SEPTEMBER 16, 2022

ADDENDUM NO. 02 to the plans and specifications for the MACOMB COUNTY JAIL, VARIOUS PROJECTS PROPOSAL A, B AND C, MT. CLEMENS, MI, Architect's Project No. 221958, dated August 26, 2022

**PROPOSAL A-SANITARY REPLACEMENT**

**PROPOSAL B-BARRIER MESH/SCREEN**

**A0.4B**

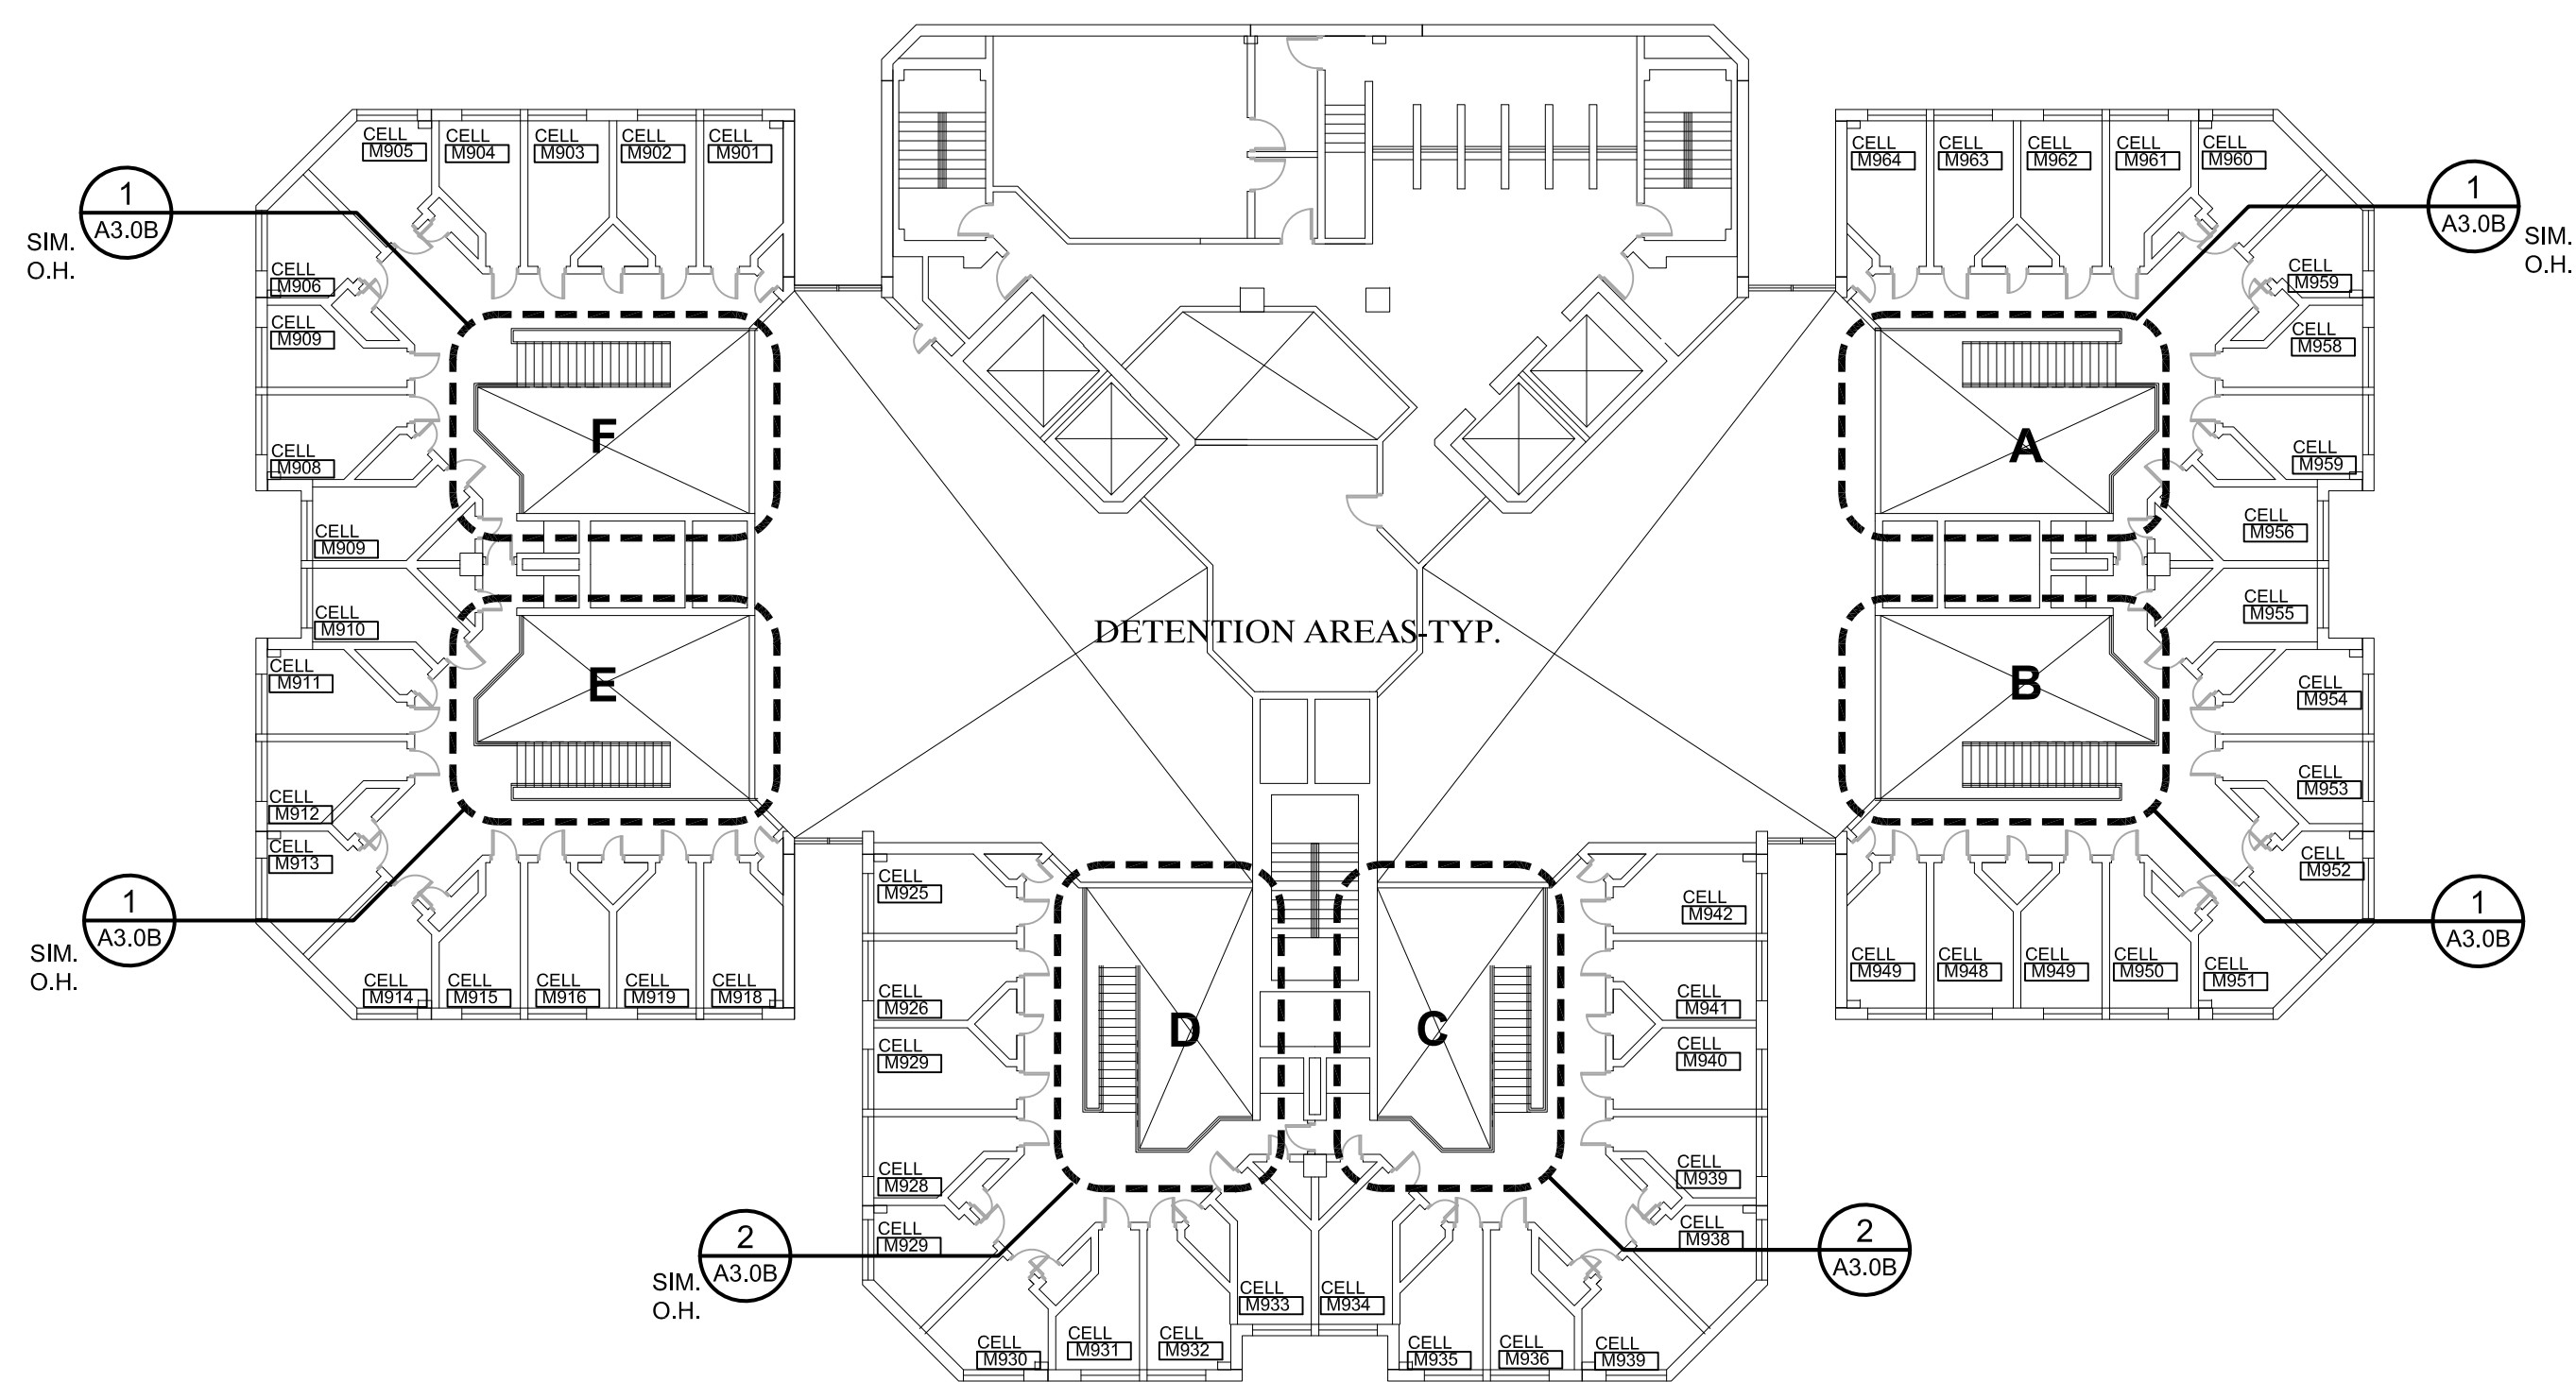
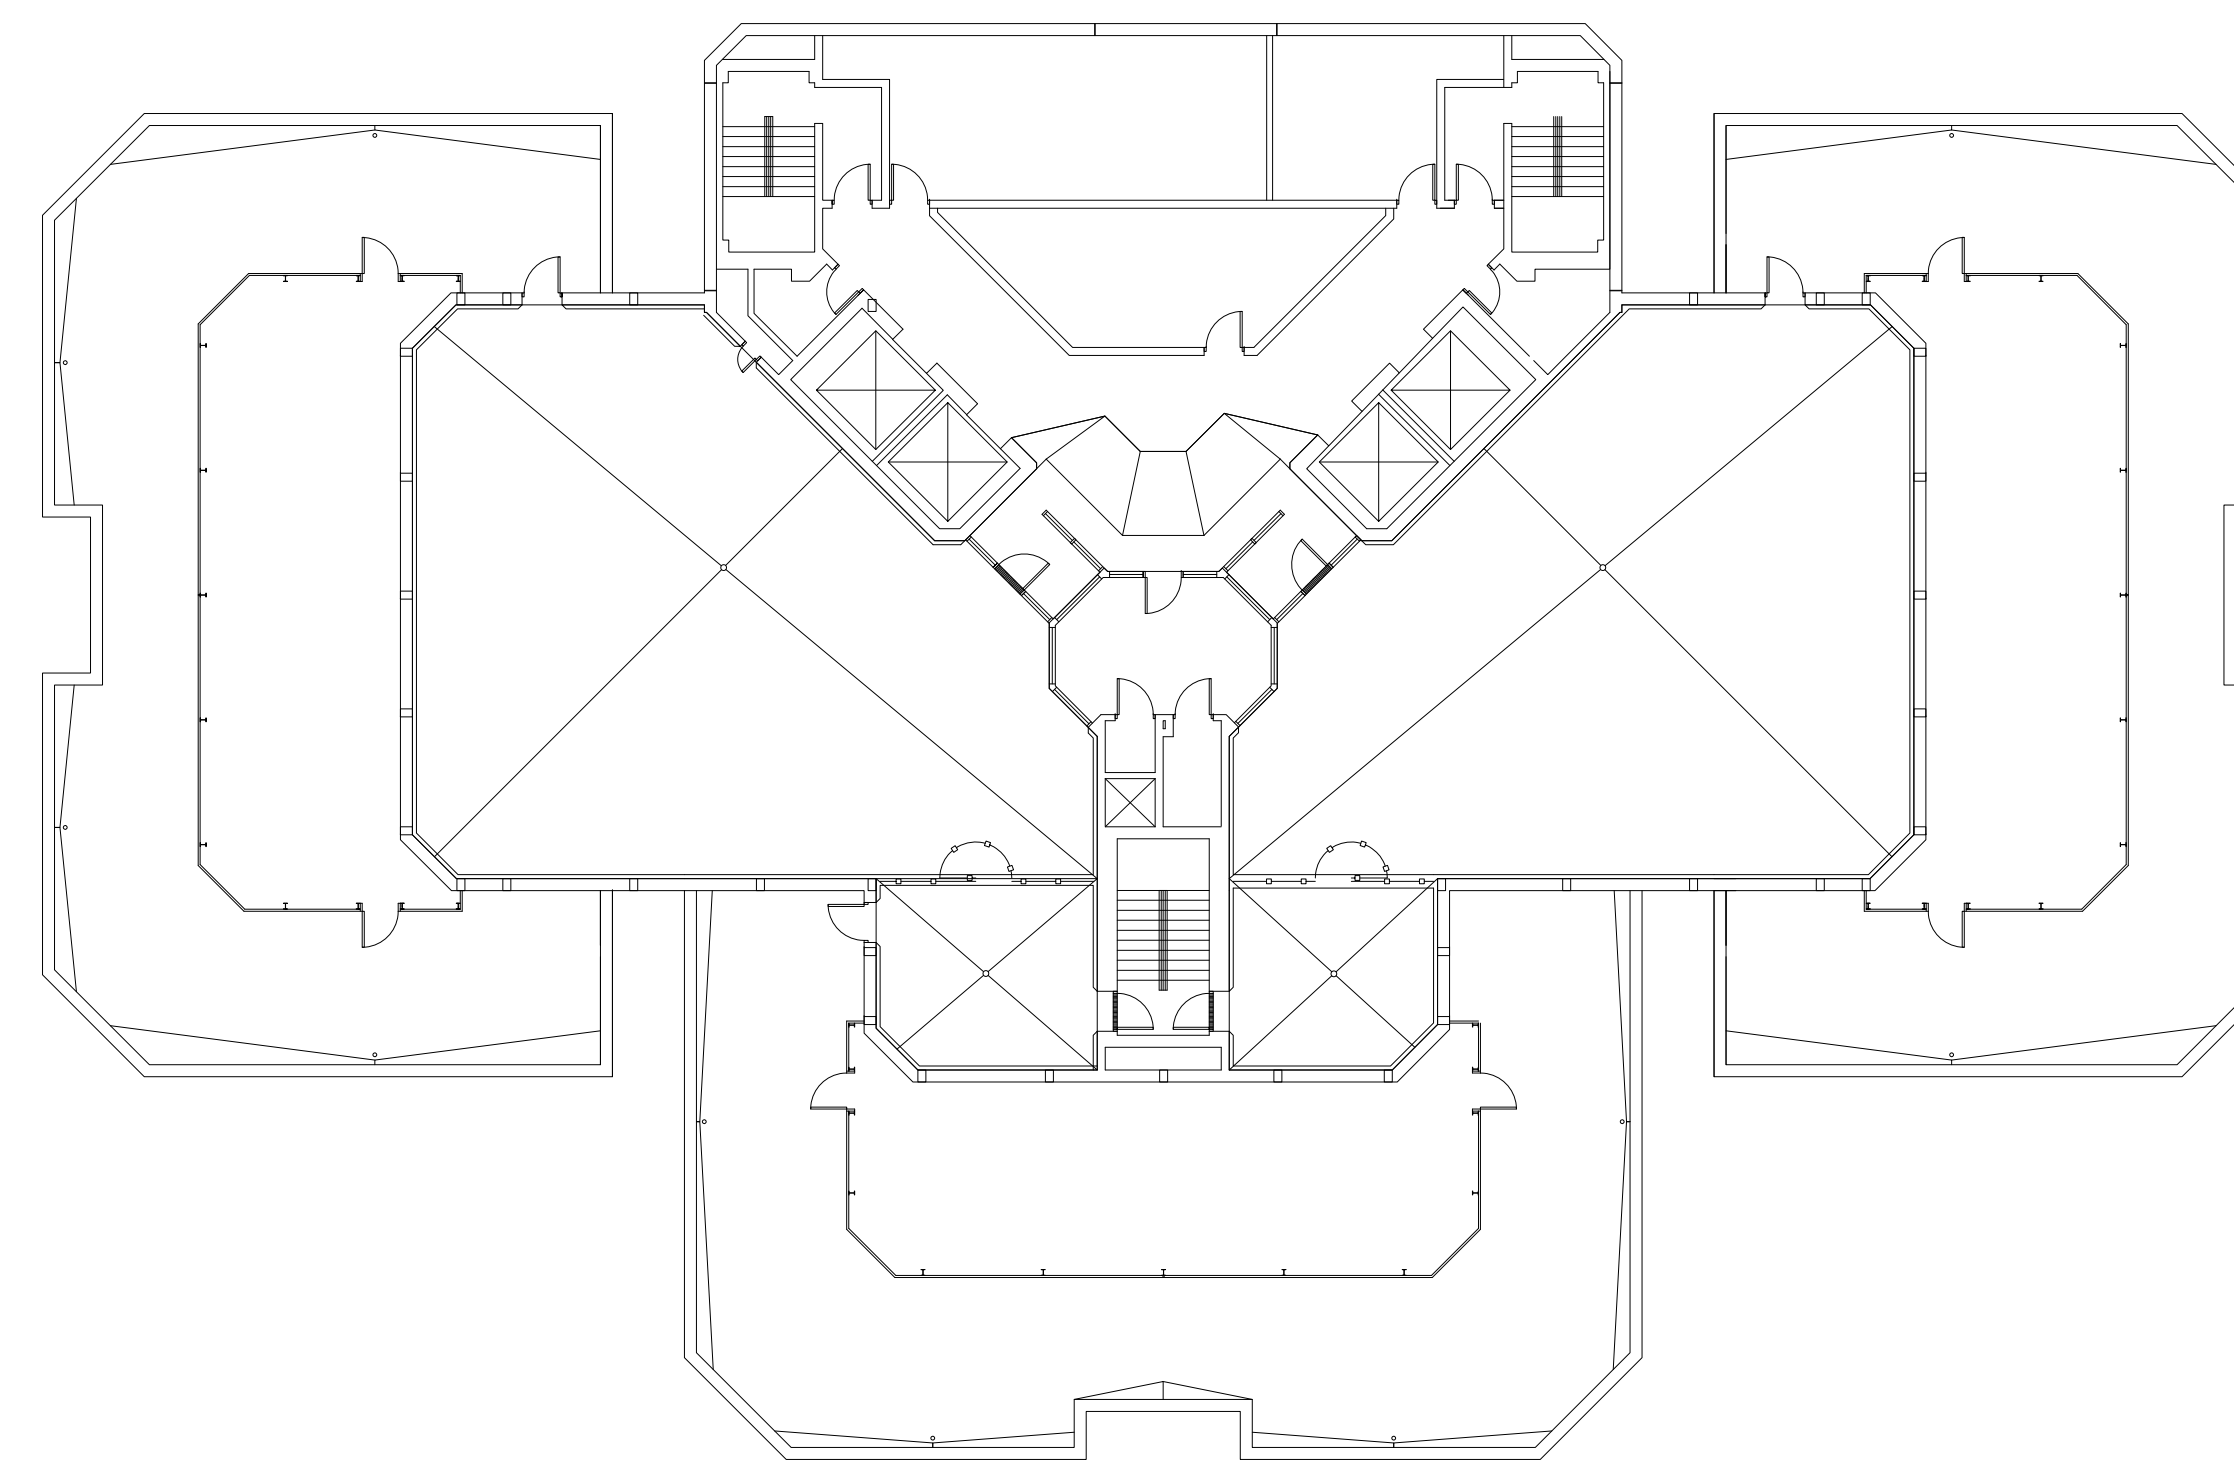
- ITEM NO. A4:** Refer to sheet A0.4A (re-issued):
1. Removed callouts 1 and 2 from the floors 8 and 10.
